JZ24-43 MARIELLA ESTATES

INITIAL PRO PLAN

Revised Initial PRO Plan: Consideration of Eligibility

Rezoning Request from RA Residential Acreage to R-1 One Family Residential with a Planned Rezoning Overlay

DATE: NOVEMBER 6, 2024
BY: 12/28/2025 PER CITY
REVISIONS
SCALE: 0' = 1" NO SCALE
JOB: 23002817
SHEET NO. 03

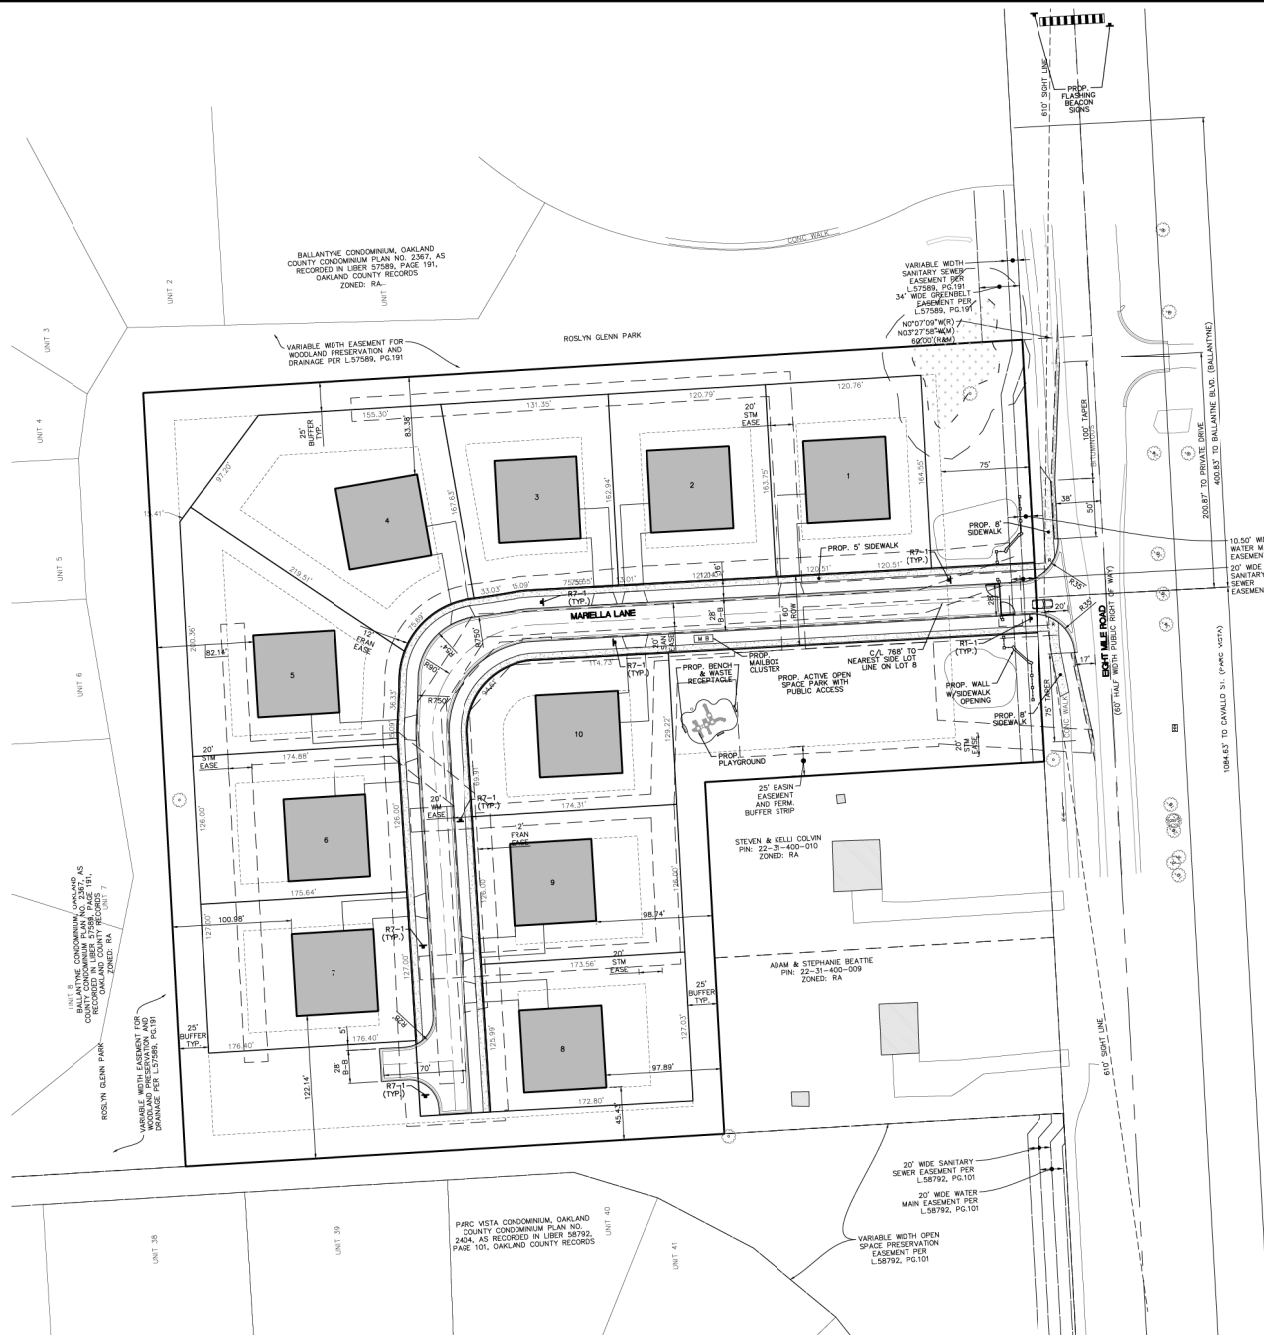
3. Sheet 04 Layout Notes state that the road will not be gated and that roads will be private, the plan shows a gate at the entrance and the road is labeled with 60' ROW. Clarify if roads will be private, revise note to state 60' private road ROW.

Response: *Understood. Following the results of the PC meeting the plans will be submitted to RCOC for review/approval.*
3. Sheet 04 Layout Notes state that the road will not be gated and that roads will be private, the plan shows a gate at the entrance and the road is labeled with 60' ROW. Clarify if roads will be private, revise note to state 60' private road ROW.

REVISIONS
AS NOTED
BY: SK, CH, CR
DATE: 12/28/2025
BOOK: 23002817
SHEET NO. 09

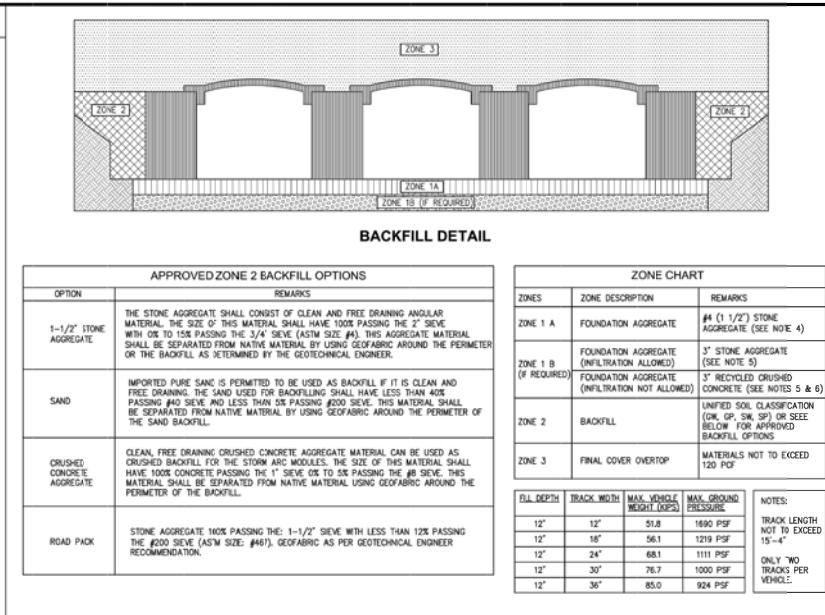
EXTERNAL SITE ACCESS AND OPERATIONS				
No.	Item	Proposed	Compliance	Remarks
1	Driveway Radii O Figure IX.3	35'	Met	
2	Driveway Width O Figure IX.3	28'	Met	
3	Driveway Taper O Figure IX.11			
3a	Taper length	75' and 100'	Met	
3b	Tangent	0' and 50'	Met	
4	Emergency Access O 11-194.a.19	-	N/A	
5	Driveway sight distance O Figure VIII-E	610'	Met	
6	Driveway spacing			
6a	Same-side O 11.216.d.1.d	400.83' and 1084.63'	Met	
6b	Opposite side O 11.216.d.1.e	200.87' to private drive	Met	
7	External coordination (Road agency)	Indicated coordination with RCOC	Met	
8	External Sidewalk Master Plan & EDM	8' proposed, tying into existing	Met	
9	Sidewalk Ramps EDM 7.4 & R-28-K	Indicated	Partially Met	Update detail to latest R-28-K version in future submittal.
10	Any Other Comments:
